Rulemaking R.11-10-023  
(Filed October 20, 2011)

**COMMENTS OF MEGAWATT STORAGE FARMS, INC.  
ON THE  
January 24, 2014 WORKSHOP STAFF PROPOSALS**

February 18, 2014

**Figure 1: Impact of 1000 MW of 1.5 Hour Storage on 10,000 MW 3 Hour Net Load Ramp**

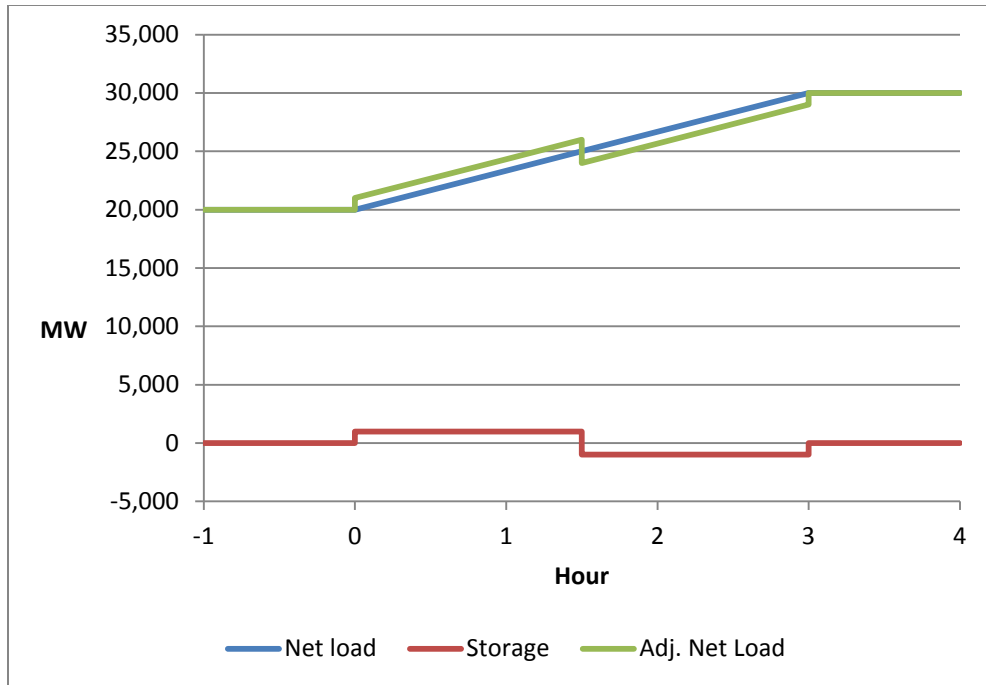
Figure 1 below illustrates this staff proposal case. As shown at the bottom of the figure, a storage facility with 1000 MW  $P_{\min}$  and 1000 MW  $P_{\max}$  and 1.5 MWH of energy storage is first charged for 1.5 hours at  $P_{\min}$  = and then discharged for 1.5 hours at  $P_{\max}$ .

The figure also shows an illustrative net load of 20,000 MW before time 0 and a 10,000 MW up-ramp over 3 hours to a 30,000 MW net load. The figure also shows the net load adjusted for this storage dispatch.

The figure shows that 1.5 hours of storage dispatch has no net impact on the 3-hour ramp. Furthermore, the increased up-ramp in the first 1.5 hours is likely to complicate the dispatch of other resources to meet the overall ramp.

MegaWatt would support a requirement that the negative output of storage also meet the full 3 hour ramp to set the  $P_{\min}$  for full EFC credit.

**Figure 2: CAISO 2020 Net Load with 4 GW of 4- Hour Storage**

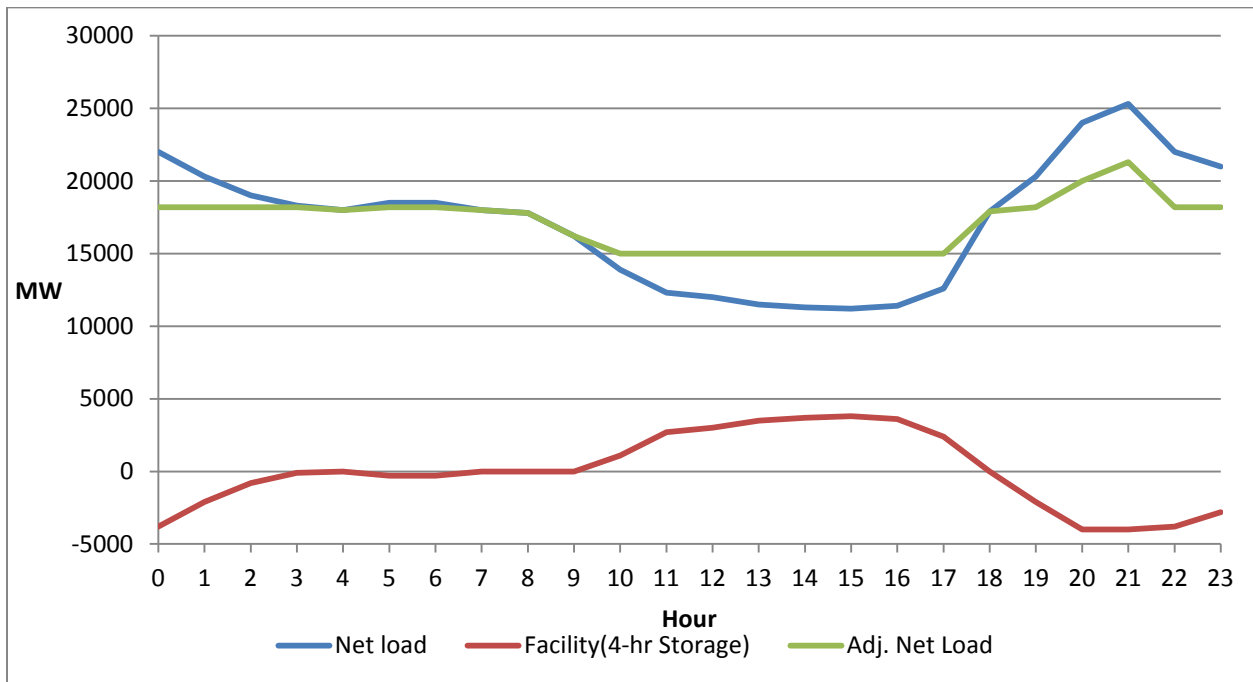
Figure 2 shows the net load for the California Duck Curve for a day in 2020.

Also shown on the figure is an illustrative dispatch of 4 GW of storage with 4 hours of energy<sup>1</sup>. The adjusted net load after application of the storage greatly reduces the net load ramp.

**Figure 3: CAISO 2020 Net Load with 4 GW of 1.5- Hour Storage**

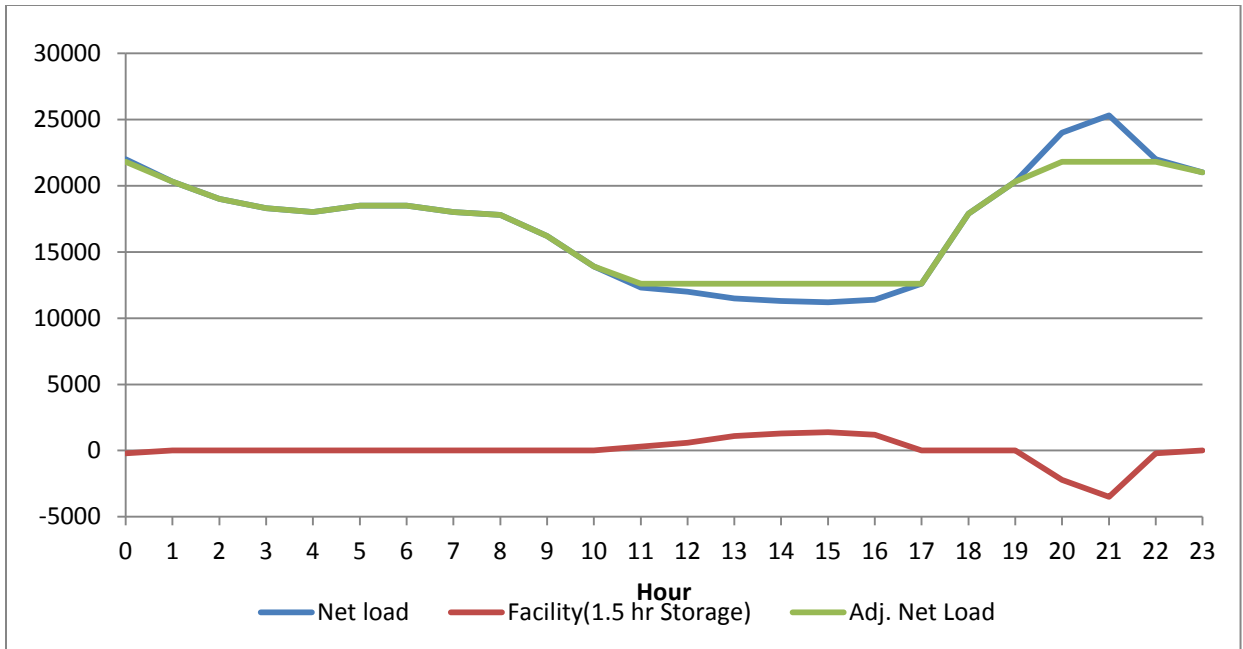
Figure 3 shows the same example with 1.5 hours of storage.

The graphs show that 1.5 hours of storage has smaller impact on the net load ramp and potential over generation at the base of the “Duck” relative to 4 and 6 hours of storage. Hence, from a longer-term perspective, QC and EFC requirements that favor short duration 1.5-hour storage will support much less renewables integration than storage facilities that are required to have 3 to 4 hours or more of storage.

**Figure 4: CAISO 2020 Net Load with 4 GW of 6- Hour Storage**

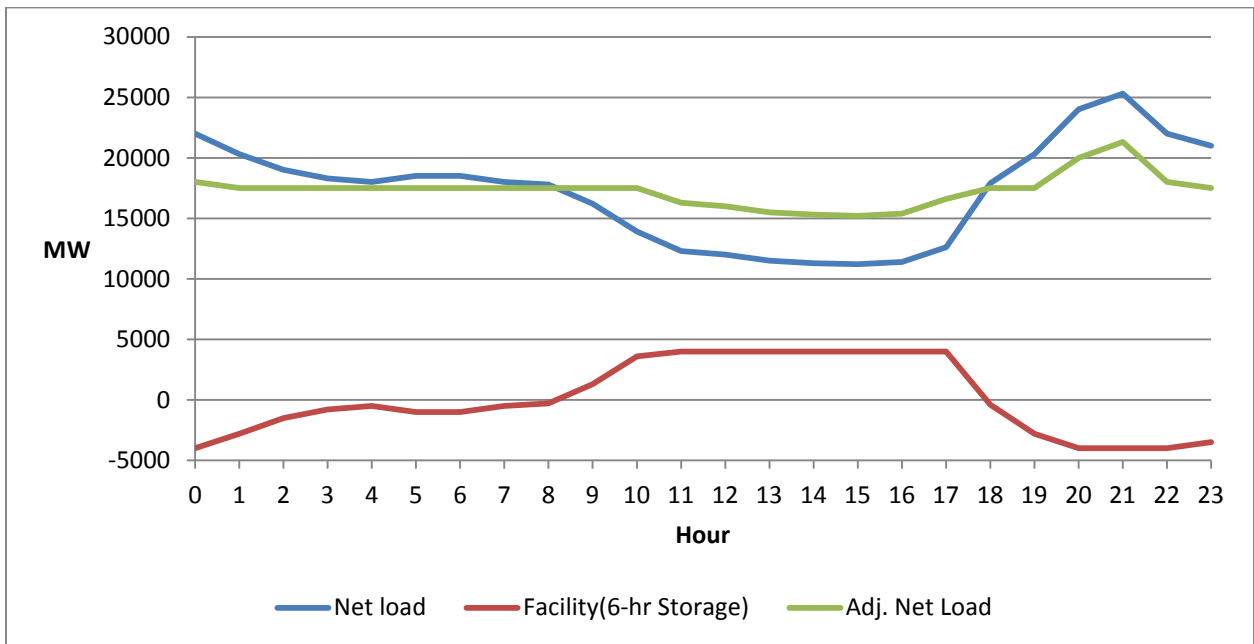
Figure 4 shows the example with 6 hours of storage.
